Submission to Central Precinct rezoning proposal

The City has reviewed the draft Explanation of Intended Effects (EIE), Design Guide, Planning Report, and supporting technical studies. **The City objects to the following aspects of the proposal**, which need to be more fully resolved to position development at Central Precinct for long term success:

Figure 11. Overshadowing of adjacent residential uses

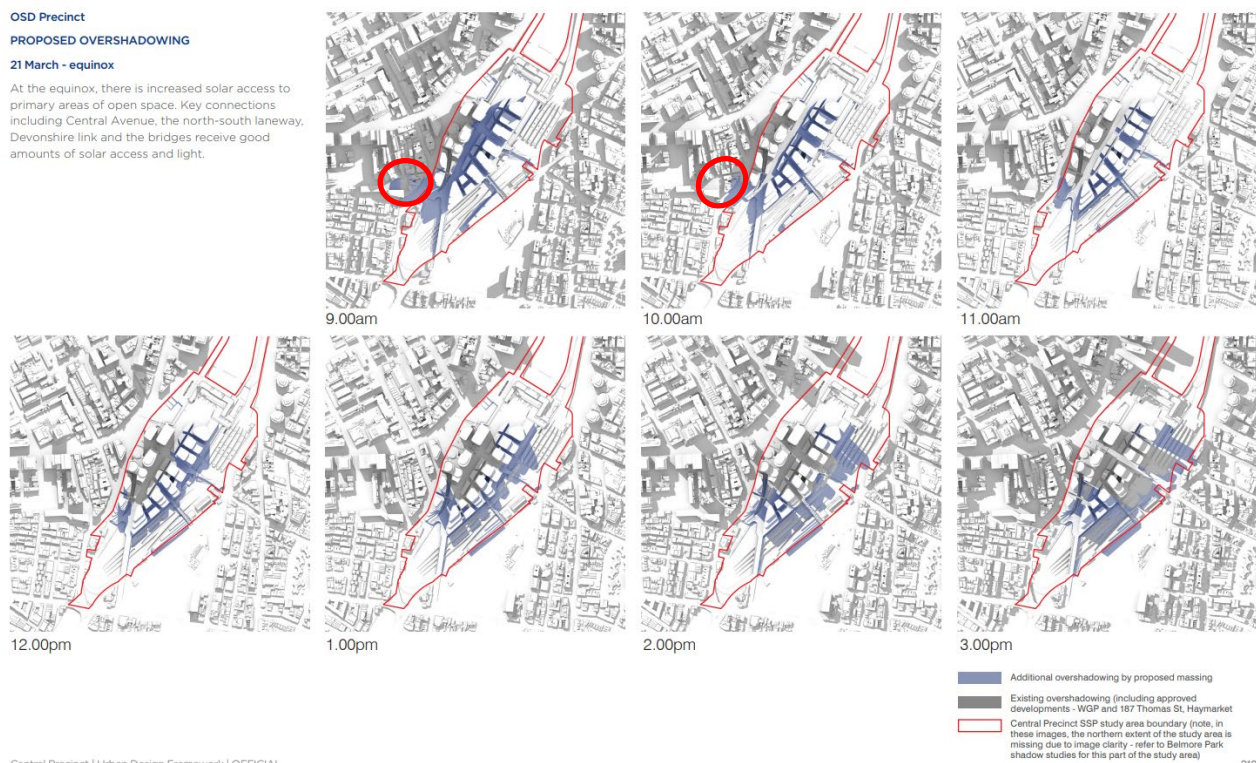
The City is concerned with the overshadowing of residential uses adjacent to and affected by the proposed development as shown in Figure 11 below. This includes, in particular, the area of Chippendale bound by Regent, Meagher, Balfour and O'Connor Streets.

Figure 19. Wind tunnel and CFD models do not accord

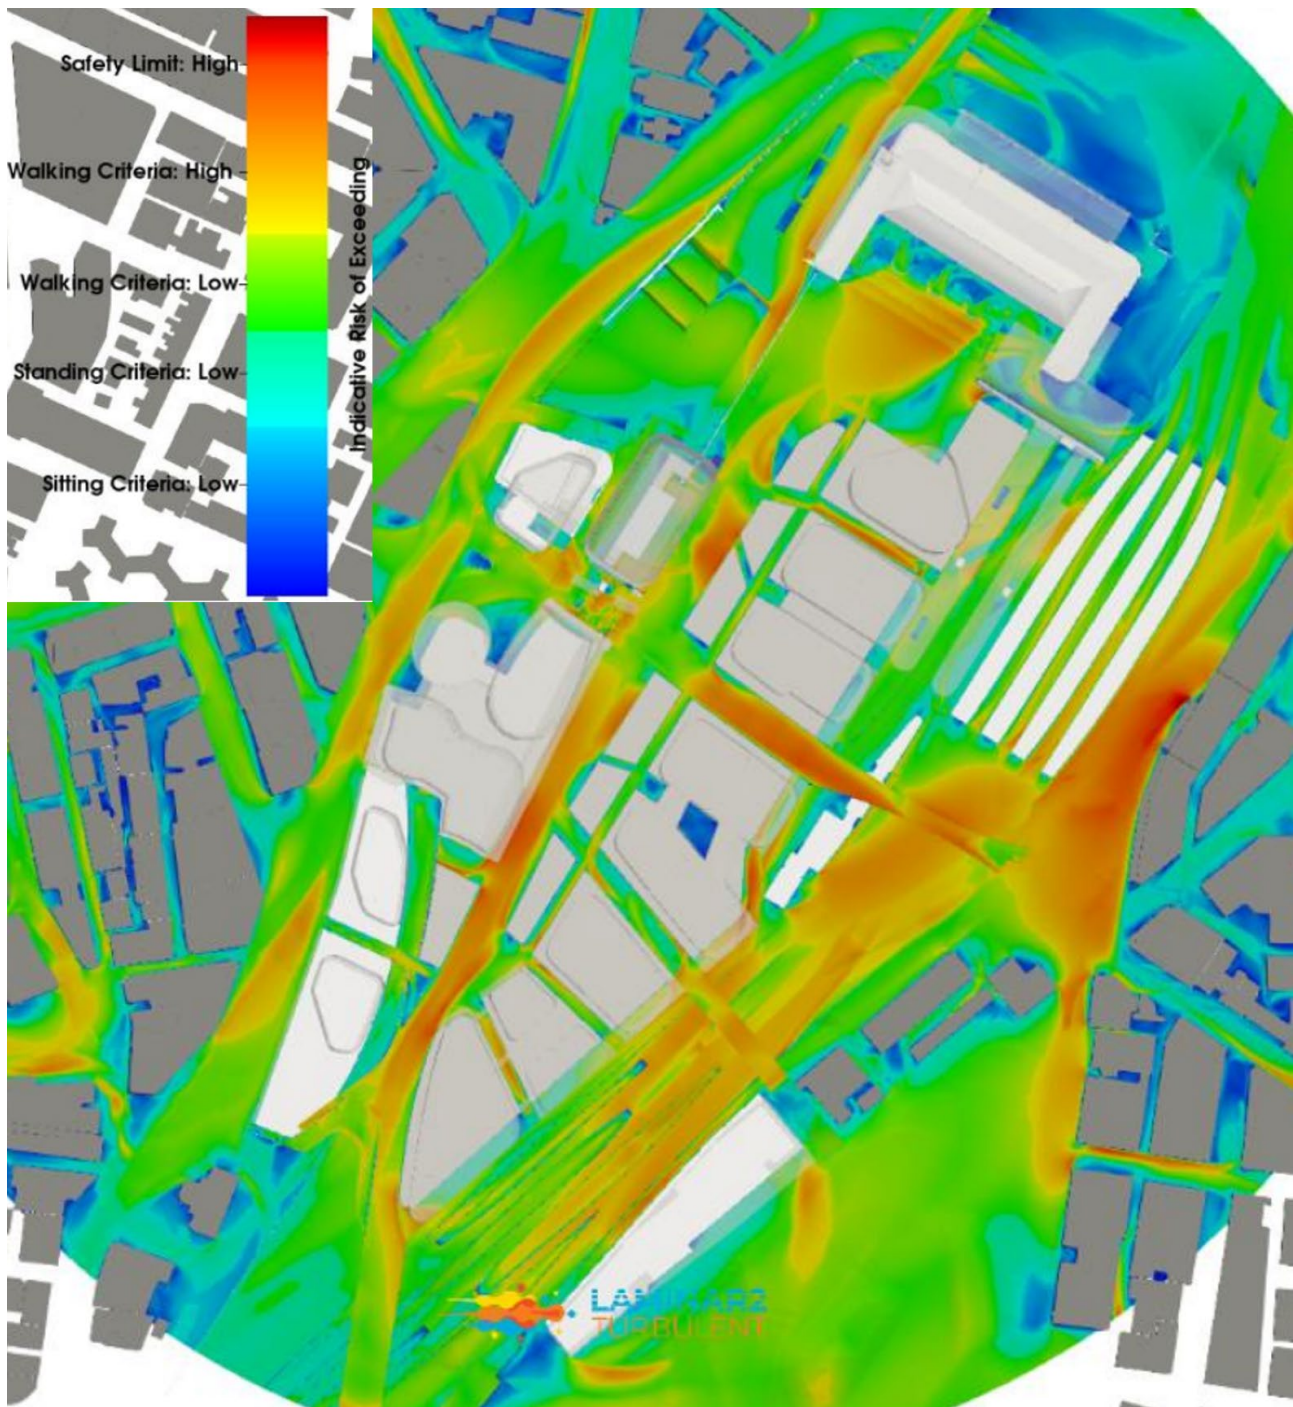
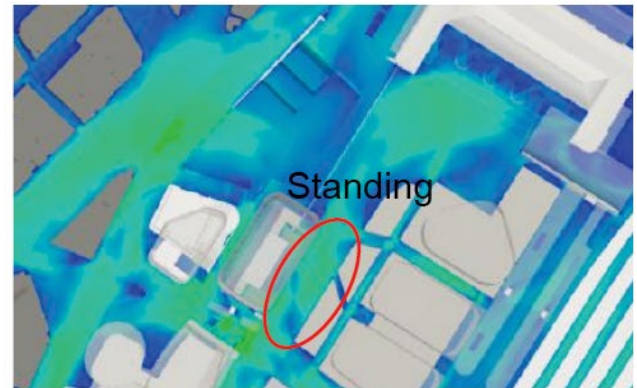
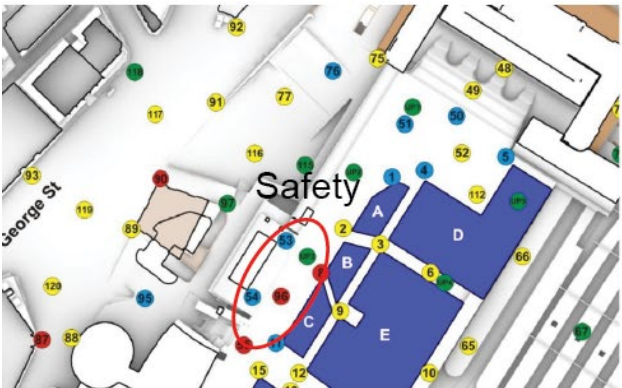
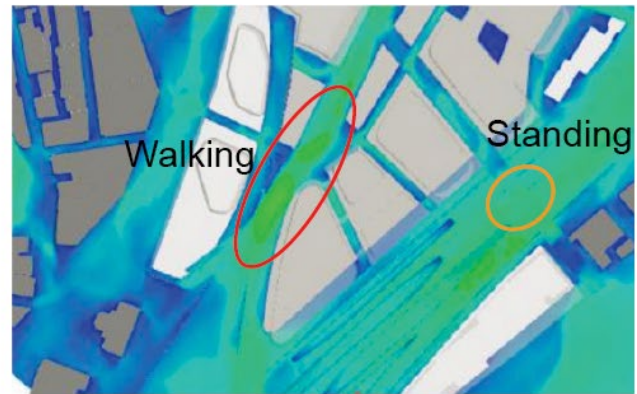
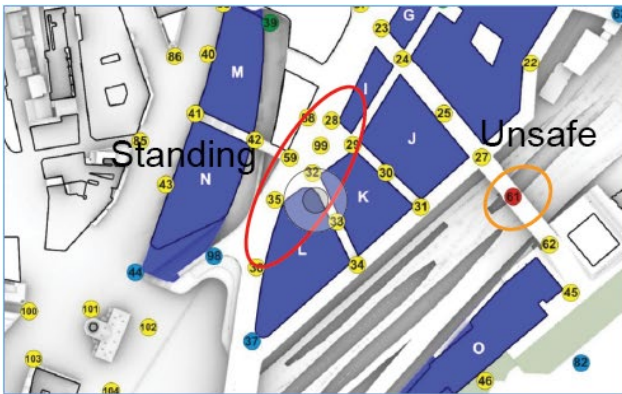
Recommendation: Undertake modelling using the methodology consistent with Sydney DCP 2012 to enable comparison to other parts of the city

Figure 3 Central Precinct sub-precincts

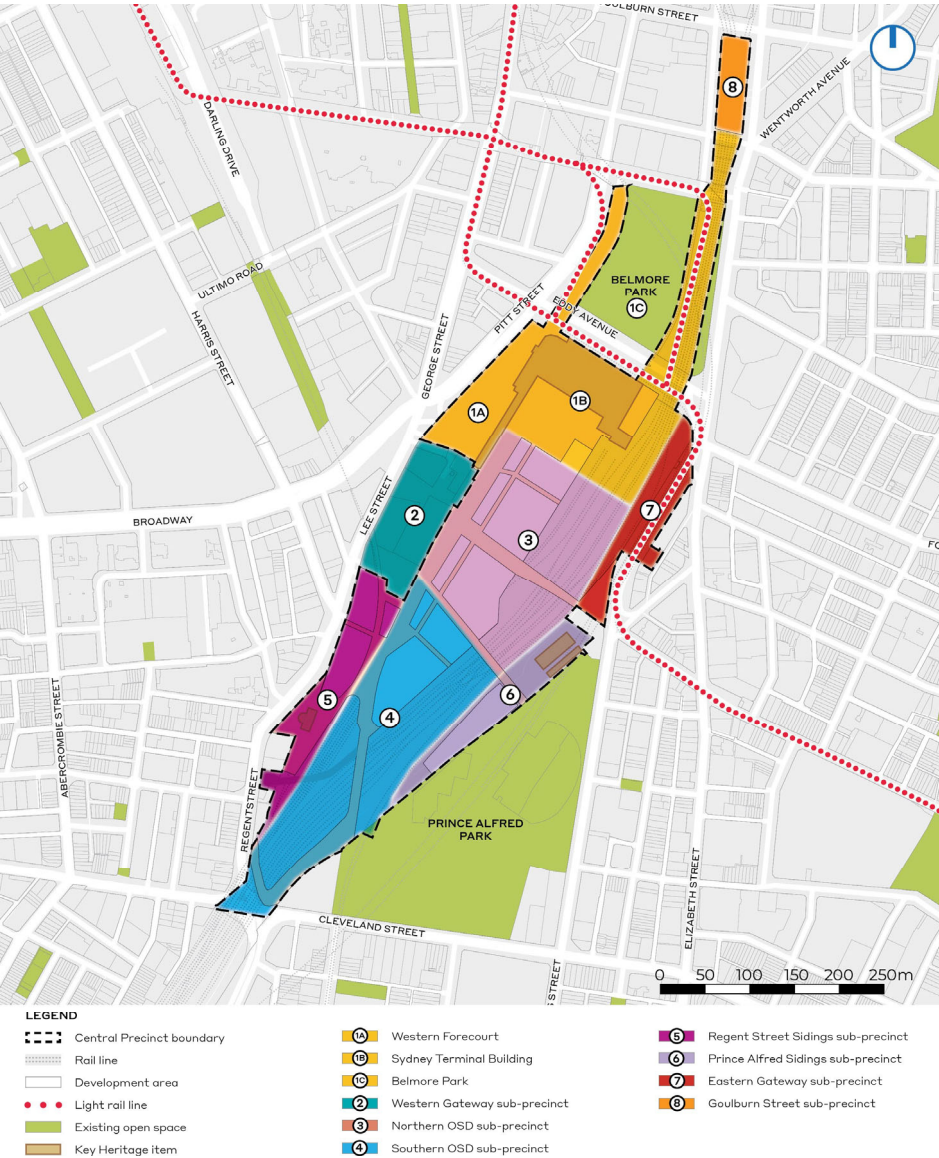
Commented [A6]: •This diagram should include the sub precinct names- it is very confusing when read with subsequent sections
•Why is Belmore Park a designated area? It is not in the SSP boundary
•1A should be given its own boundary

Figure 16 Typical cross-section 6, Eastern Colonnade

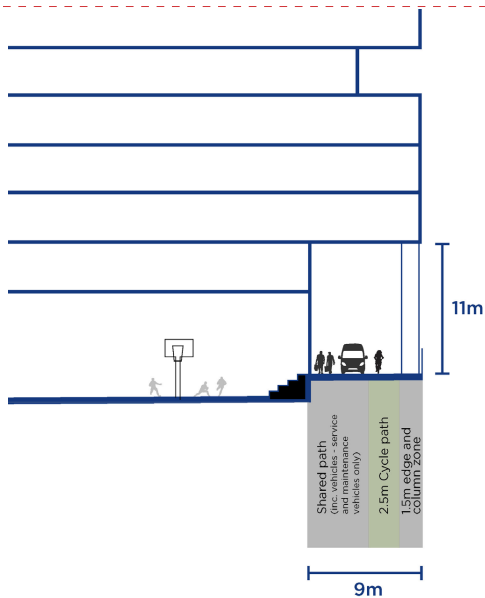
Commented [A56]: •Clarify the type of vehicles that will have access to the shared path (e.g. delivery vehicles, emergency vehicles)?
 • Clarify if the cyclepath two-way or one direction only?
 • What other activity/movement may occur along the Eastern Colonnade?
 • How will emergency vehicles turn around?
 • How will building maintenance for the towers adjacent be managed?

Figure 28 Central Precinct wind criteria for key streets, lanes and through-site links

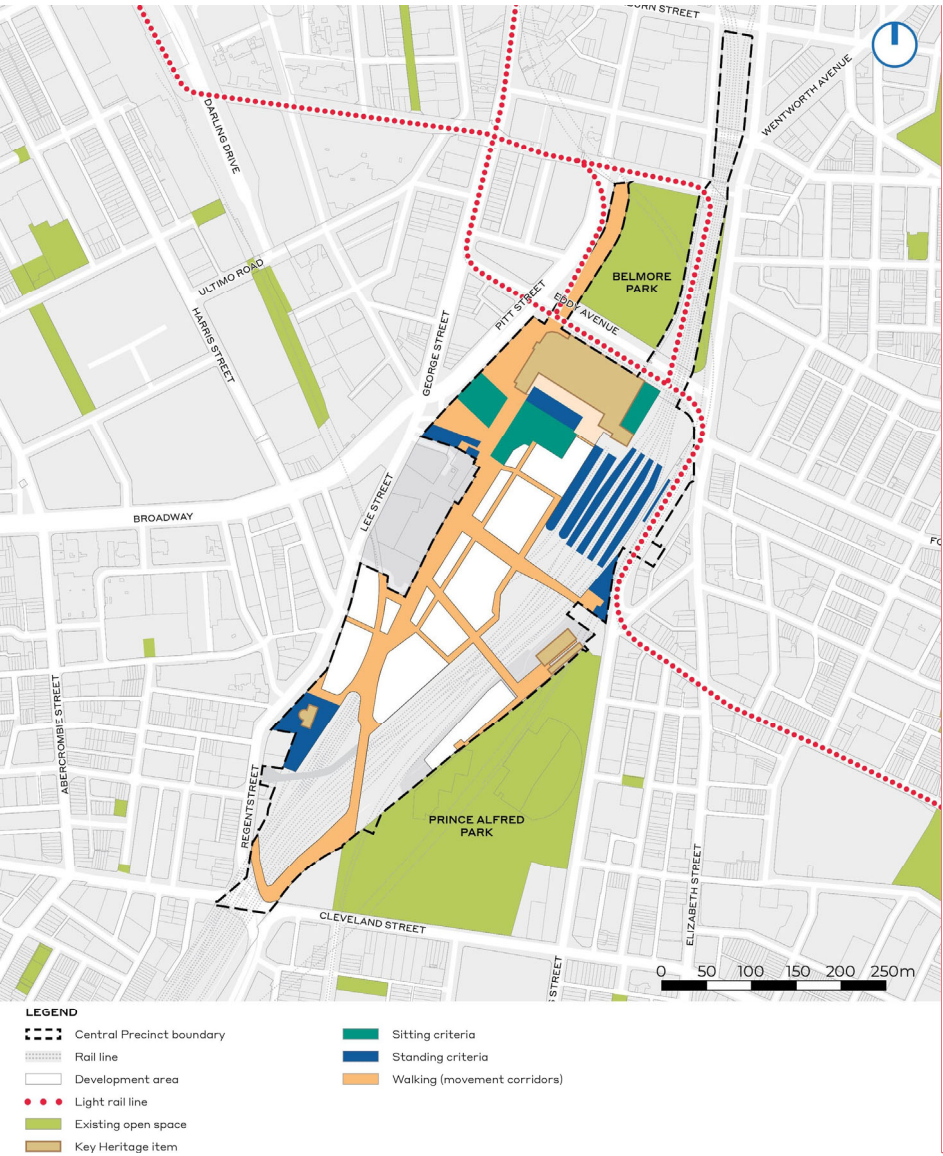
Commented [A71]: Previous section shows where outdoor dining is encouraged, *subject to wind conditions*. Given the map at Figure 28 does not show any sitting in the streets, the 2 controls contradict each other and these controls will allow zero outdoor dining.

Commented [A72]: Poor wind conditions should be ameliorated through the placement of buildings and manipulation of the built form, not mitigated with devices, especially in the public domain.

Commented [A73]: The north-south laneway has been identified as an eat street. It should be identified 'sitting criteria' along with all active frontages on OSD buildings.

Figure 30 Central Precinct vehicle network

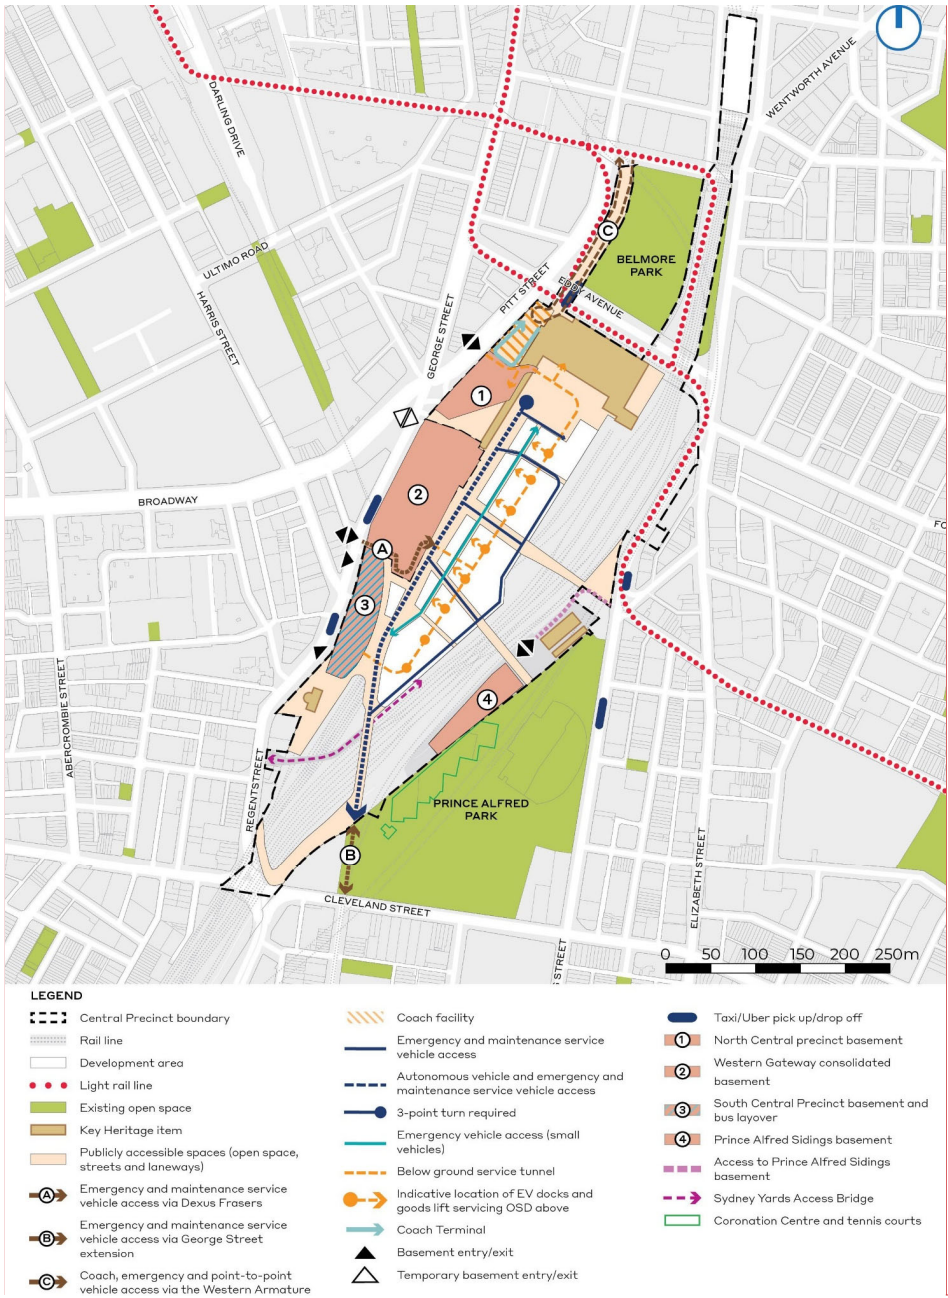
Commented [A74]: The long term use of the temporary basement entry at Lee St is not supported, these controls must state this.

Figure 37 Central Precinct upper level setbacks and separation distances

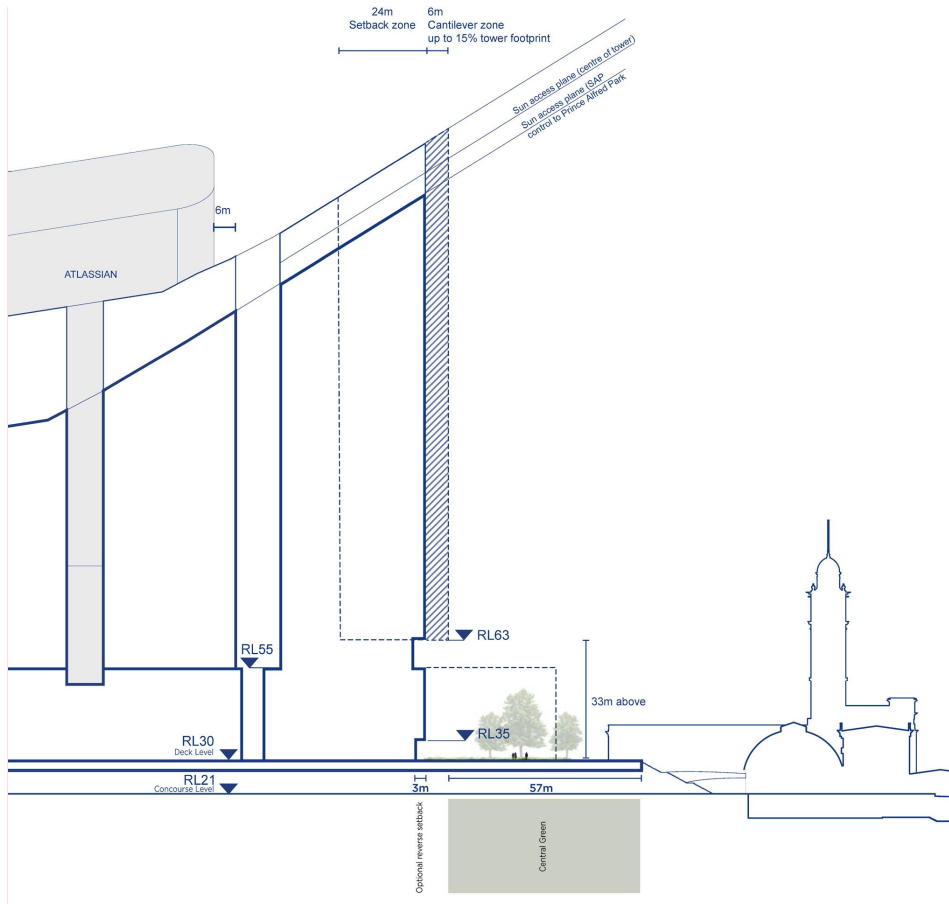
Commented [A97]: The upper level setbacks are inconsistent with the SDCP. It must be demonstrated that the reference design can achieve the desired wind comfort criteria.

Figure 39 East-West Section – Block A1 interface to Central Green

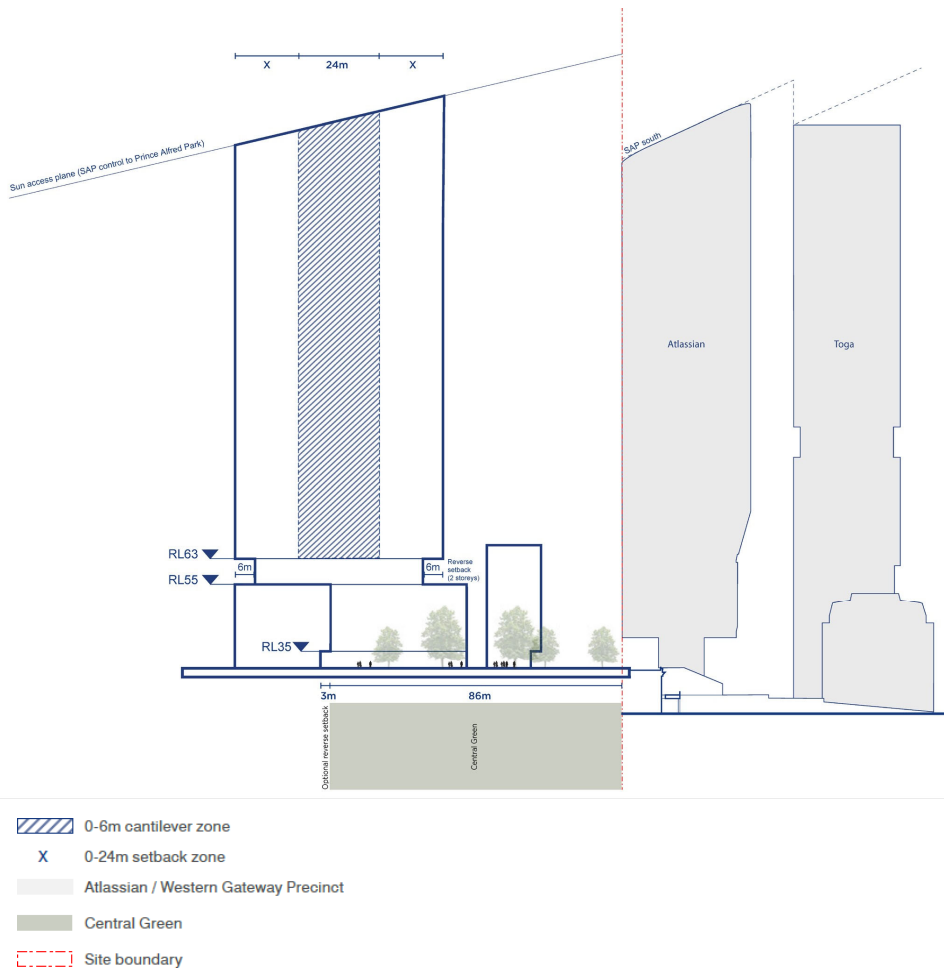
Commented [A98]: Cantilevered built form over Central Green is unacceptable and should be removed as a control

Figure 6 Discrepancies with southern cycleway

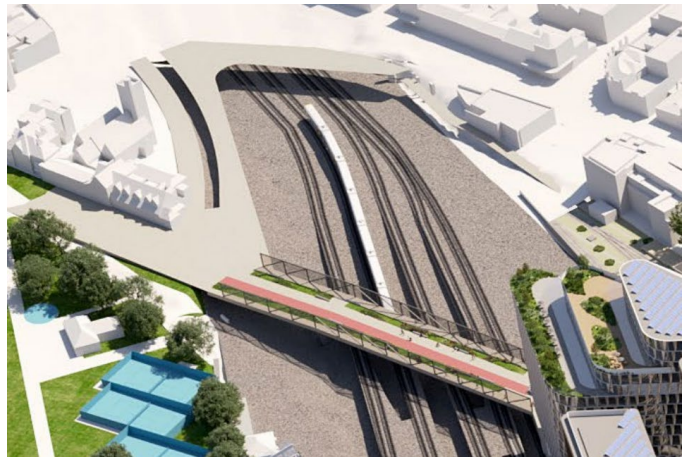
The design of the crossing must conform to the specifications set out in Item 5.1.

Figure 7 Devonshire tunnel east entrance (Source: Urban Design Report, Figure 292)

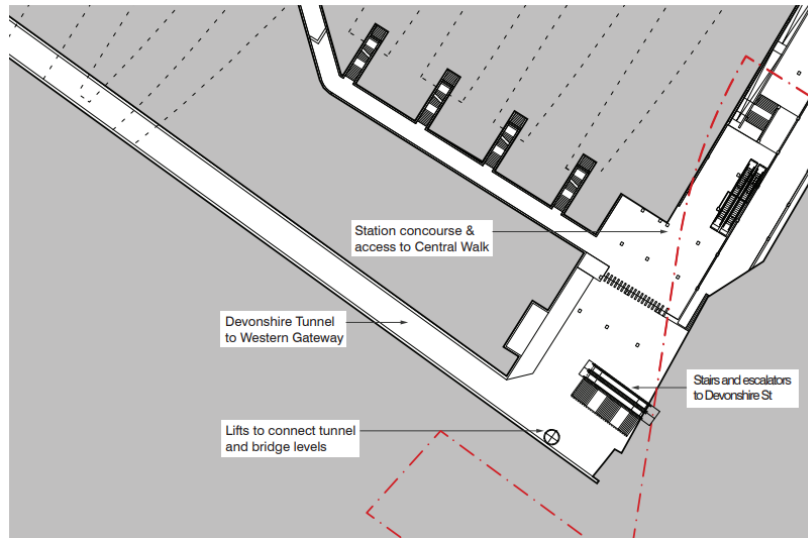
- how staging will work For Devonshire Tunnel to function as a bike connection, the west half of Central Walk will need to be complete and able to act as the main pedestrian connection. It is unclear what will happen in the interim

Figure 9 2036 PM Central Precinct Demand (Source: Transport Assessment Figure 5-7)

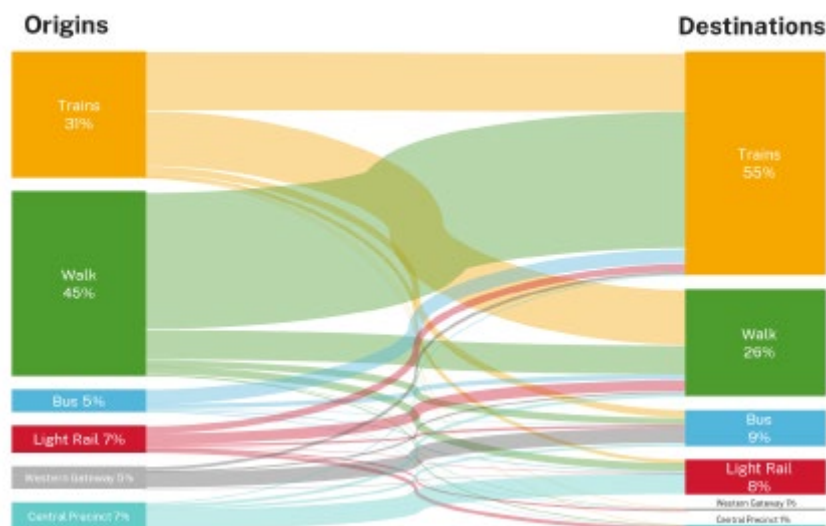
Figure 5-7 in the Transport Assessment shows the vast majority of trips departing Central Precinct in the evening peak use light rail (see Figure 9 below). This seems odd; one would expect that it should mirror the AM peak where most people arrive via train. The City requests that this analysis is reviewed.
